APPLICATION REVIEW Z-23-33

PLANNED UNIT DEVELOPMENT (PUD) APPROVAL OF FINAL PLAN

Annie Briscoe, Kimley-Horn and Associates, Inc. On behalf of City of Waco For Callan Village PUD, Phase 3 – Fire Station 15 10905 Panther Way (Lot 3, Block 1, Ritchie Road Water Tower Addition)

Final Plan

APPENDIX I LANDSCAPE PLAN

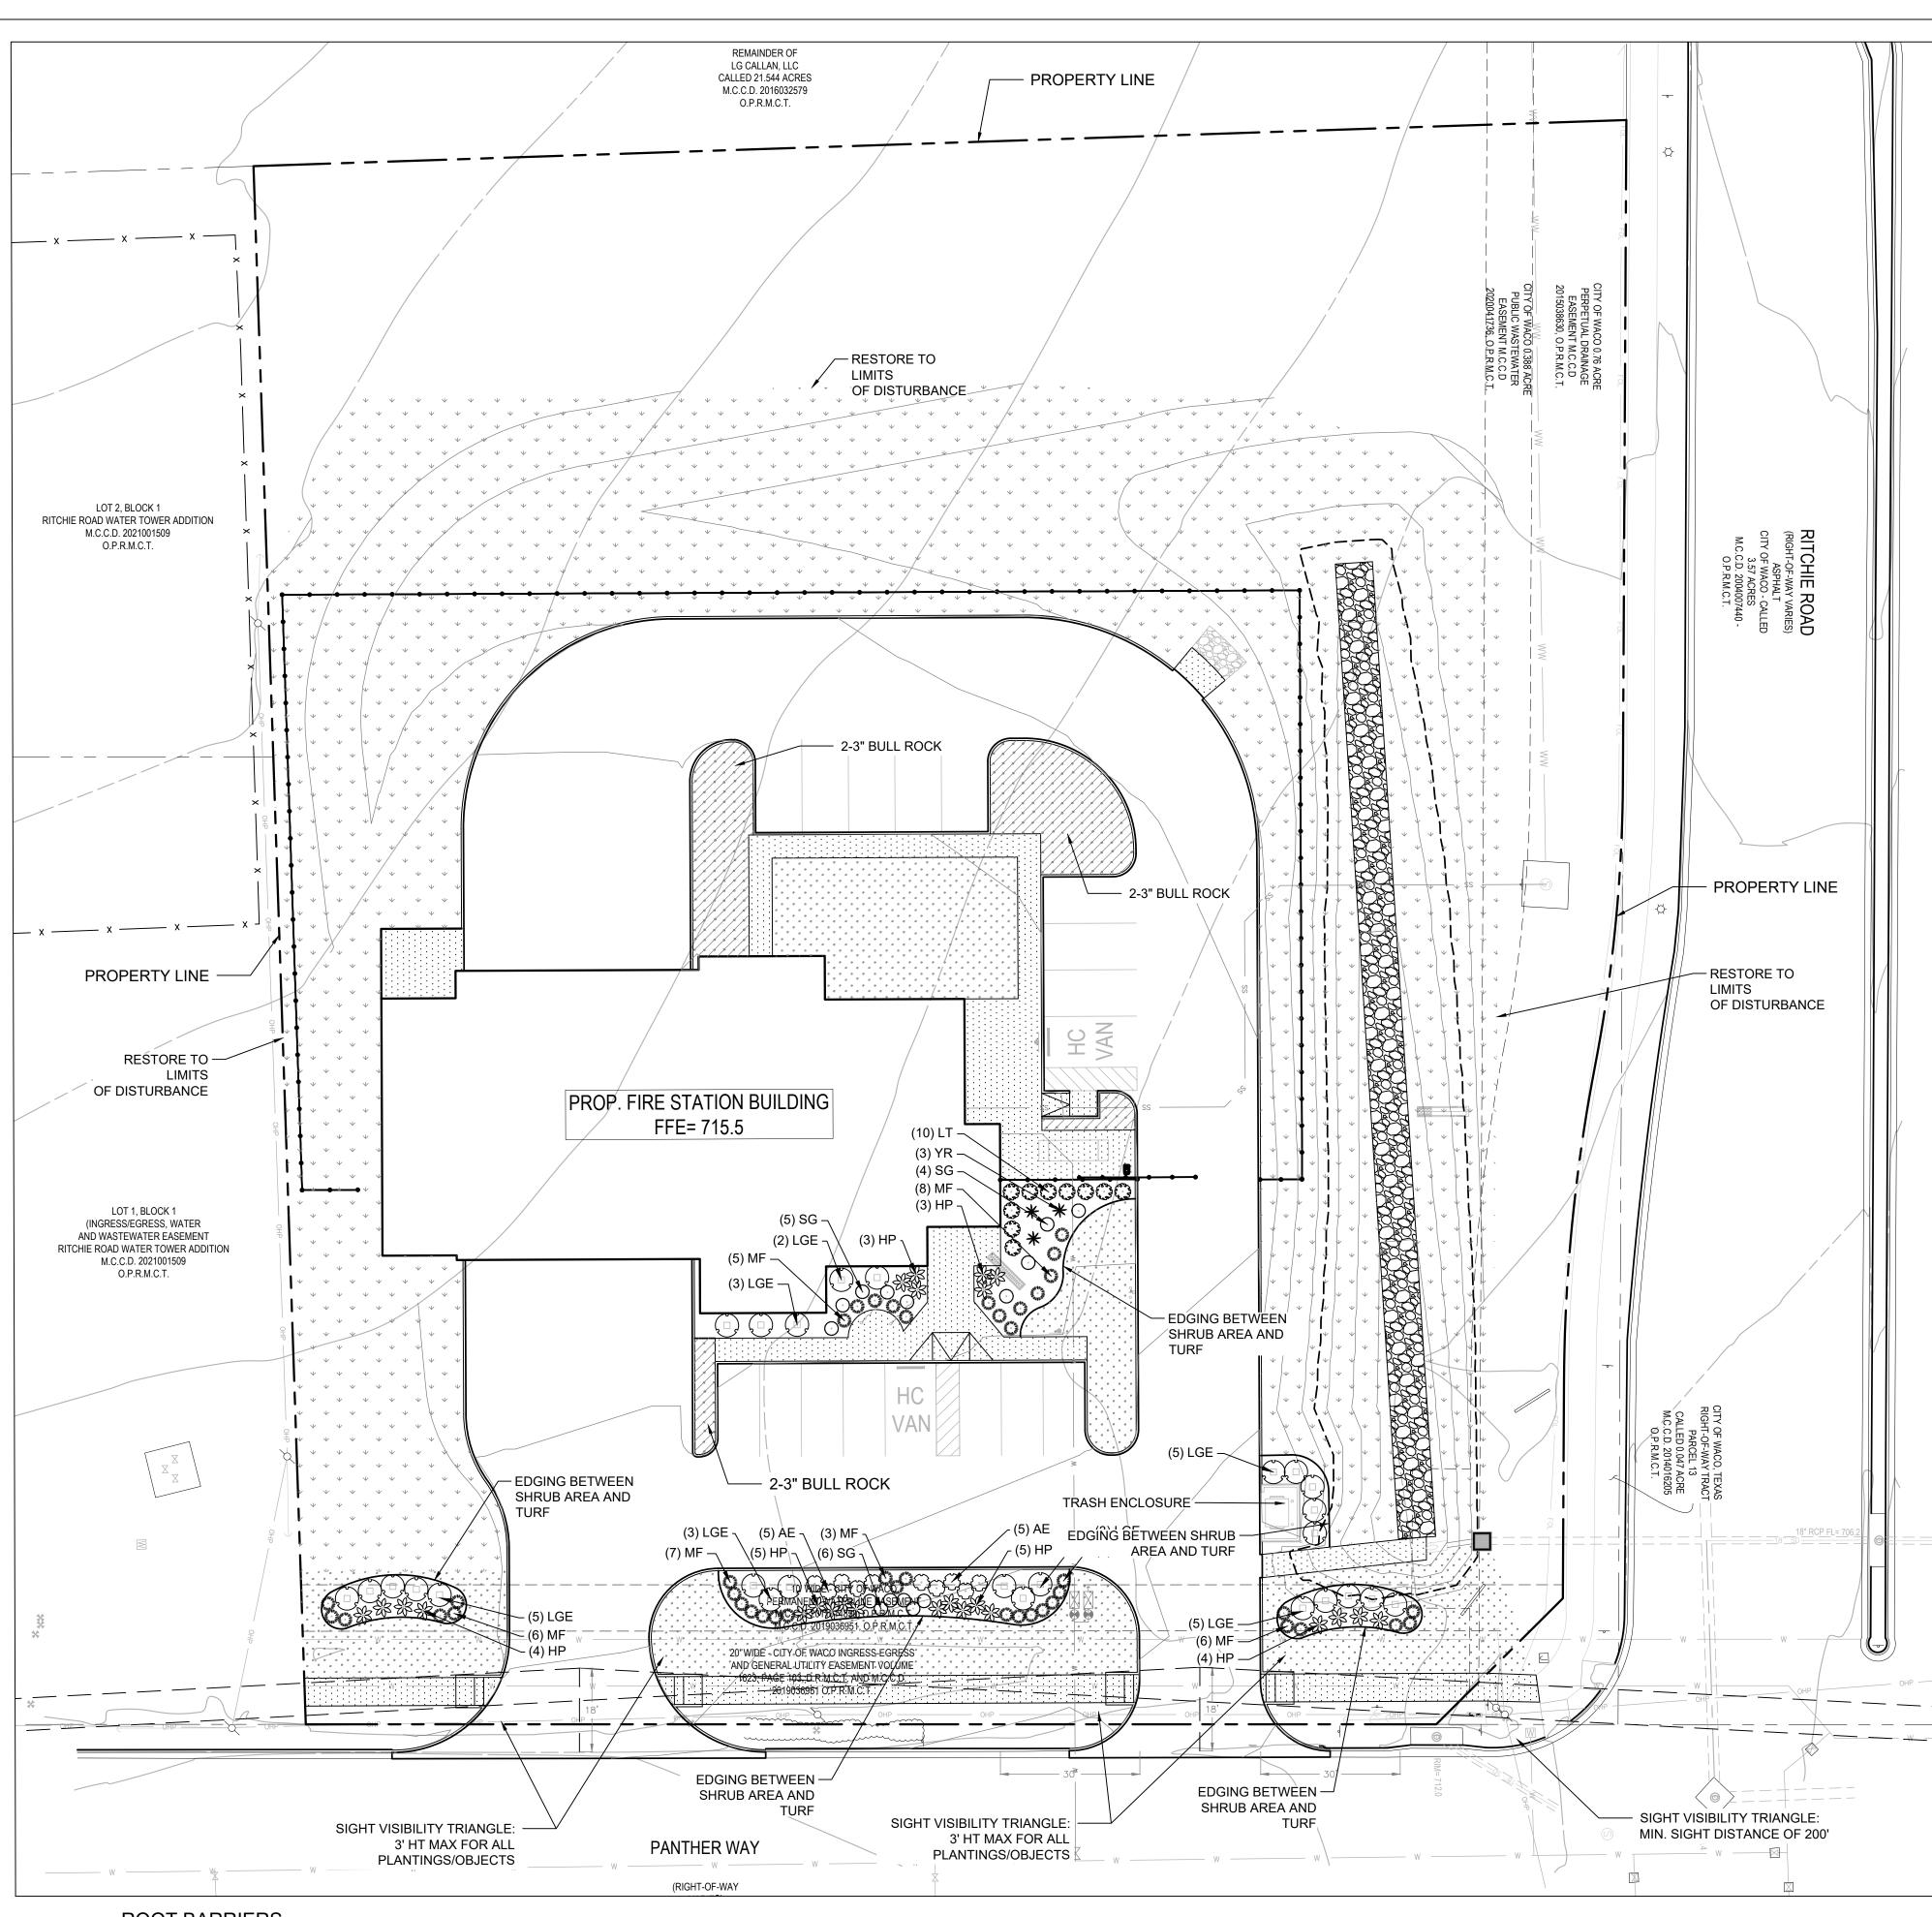
- 1. Boundary landscaping shall be installed along the Ritchie Road frontage in accordance with Section 28-218(c) of the City of Waco Zoning Ordinance.
- 2. Boundary landscaping shall be installed along the Panther Way frontage that exceeds the requirements of Section 28-218(c) of the City of Waco Zoning Ordinance, as follows:
 - a. An all-season landscape screen four feet in width densely planted with a combination of deciduous and evergreen trees and shrubs which have an initial height of three feet. Trees shall attain a height of six feet within 36 months after installation. Shrubs will attain a maximum height of four feet within 36 months after installation.
 - b. Landscape screening shall be installed in a way that does not create a site distance issue for driveways.
